## QUESTIONS

### **FOR THE REQUEST FOR PROPOSAL FOR THE NON POINT SOURCE BIG SIOUX RIVER BANK STABILIZATION PROFESSIONAL ENGINEERING SERVICES NEAR SIOUX FALLS, SOUTH DAKOTA**

Date updated: **February 15, 2017**

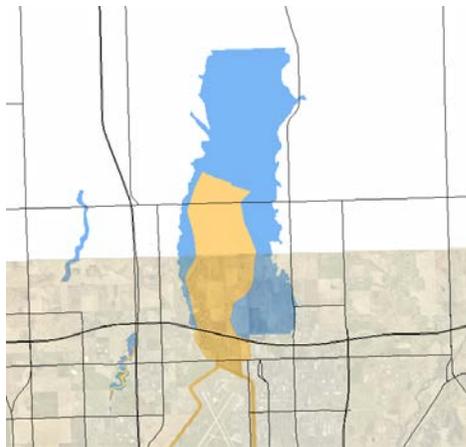
5. The City currently has about a dozen tree logs available for use if they are needed. The top photo shows an example of the trees. And the bottom photo shows an example of how we have used the trees in the past. This photo is site 403 where one of the trees was used in a spur.
